Subject: **L.E. Carpenter & Company, Wharton New Jersey, NJD002168748**
Source Reduction Remedial Action Workplan Comment Response

L.E. CARPENTER SOURCE REDUCTION REMEDIAL ACTION WORK PLAN (RAWP)

Response to NJDEP Comment Letter Dated October 20, 2004 and USEPA Comment Letter Date October 19, 2004

**CONFIRMATORY PCB SAMPLE PLAN LOCATION
(RAWP FIGURE 24, REV. 1)**

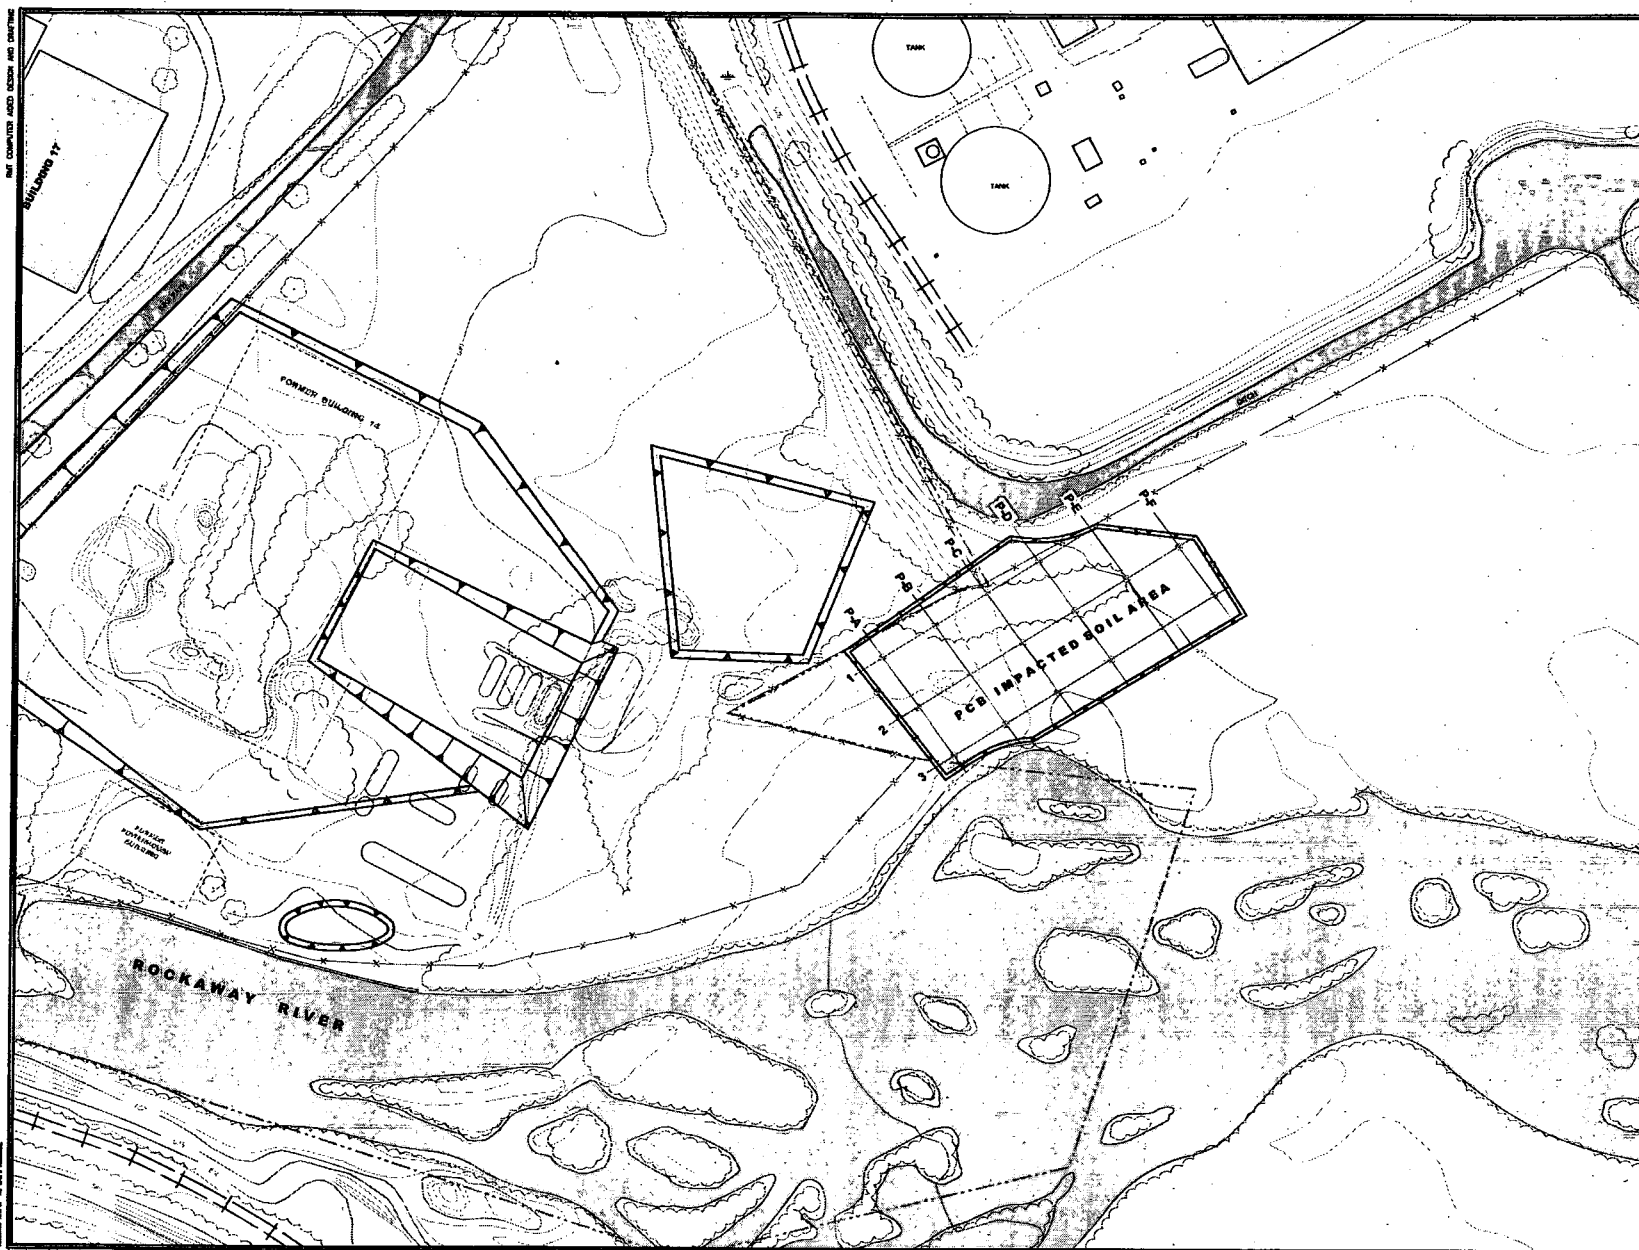
PCB Confirmatory Sampling - LEC proposes bottom and sidewall excavation verification samples per N.J.A.C. 7:26E with respect to the PCB soil removal and we have provided those locations on the attached revision to RAWP Figure 24. This sampling plan includes sidewall sampling at a lineal wall interval of 30 feet and floor sampling at one sample per 900 square feet and which is equivalent to a grid spacing of 30 feet.

**PROPOSED VERIFICATION SAMPLES FOR LEAD SOILS EXCAVATIONS
(RAWP FIGURE 22, REV. 1)**

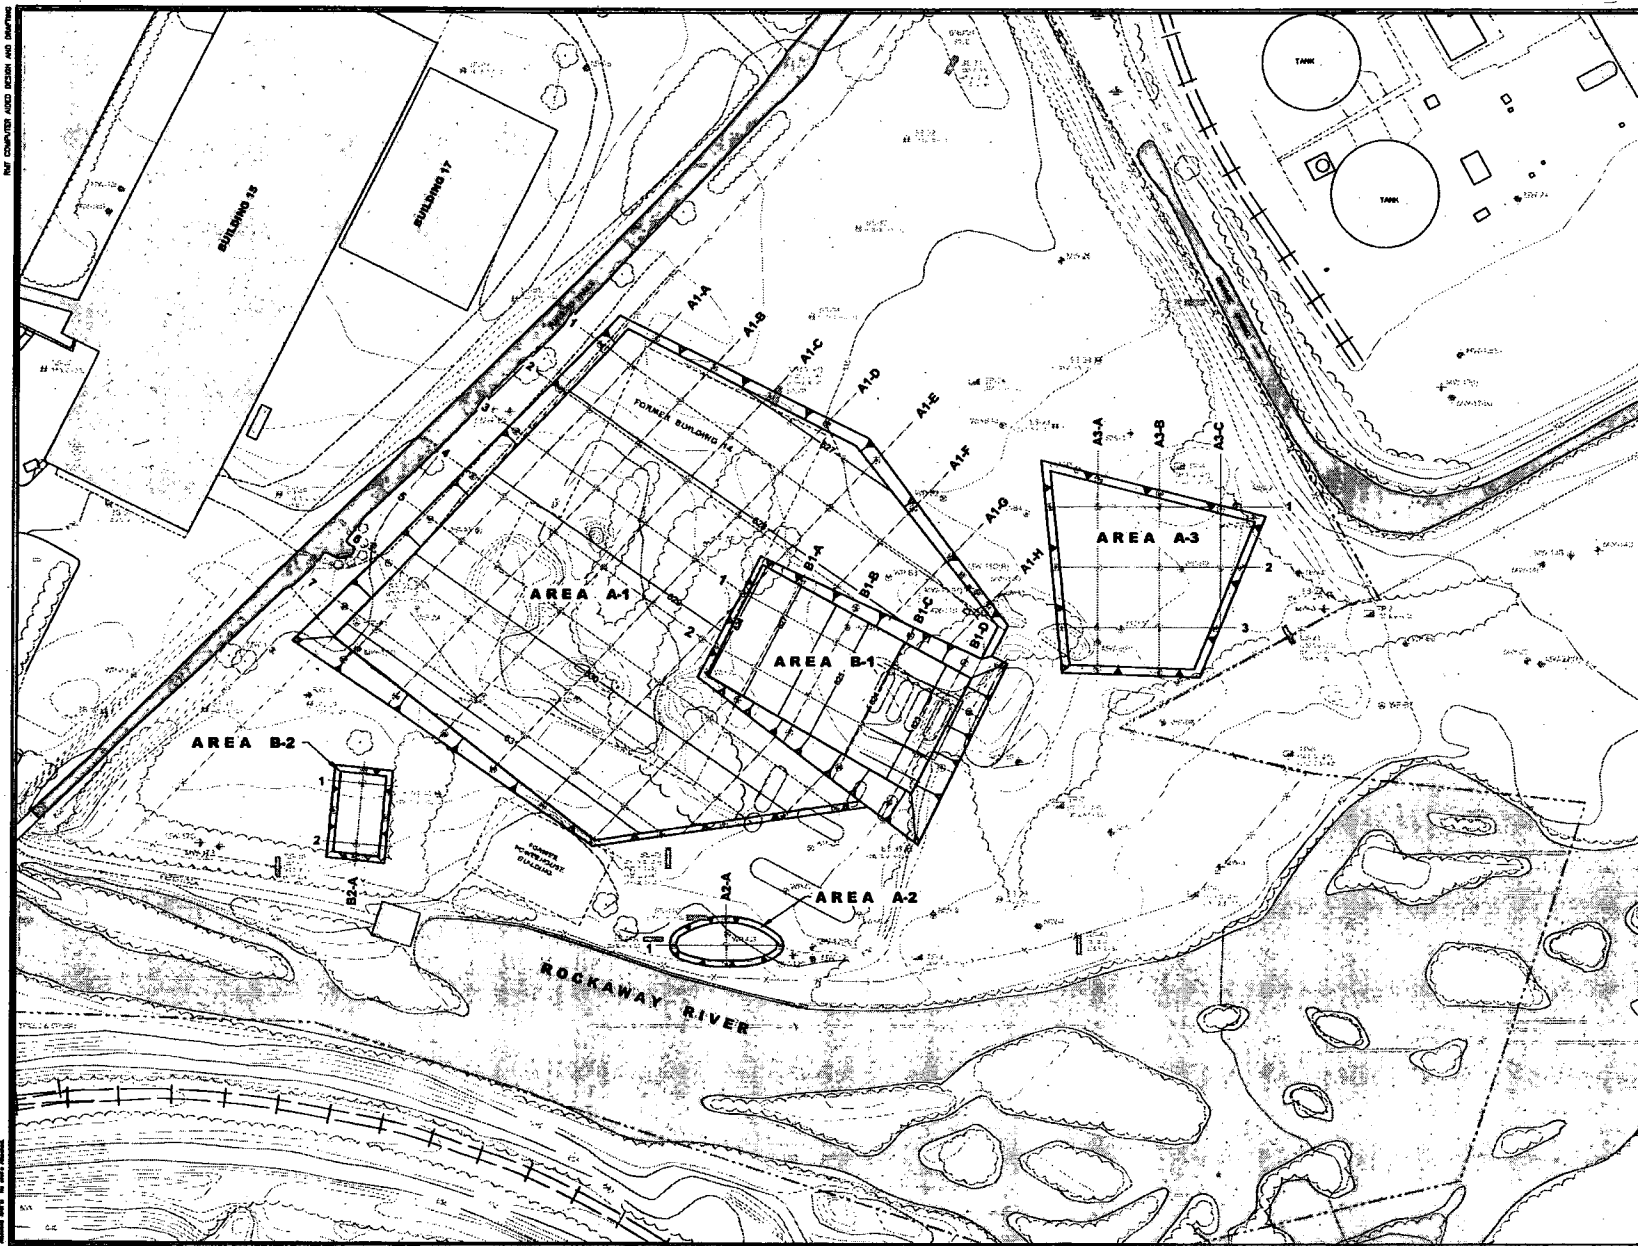
Proposed Additional Confirmatory Sample Locations - LEC proposes bottom and sidewall excavation verification samples per N.J.A.C. 7:26E. The attached revised RAWP Figure 22 shows the proposed post-excavation sample locations that will be used to assure adequate removal of lead and PCB soils. This sampling plan includes sidewall sampling at a lineal wall interval of 30 feet and floor sampling at one sample per 900 square feet and which is equivalent to a grid spacing of 30 feet.
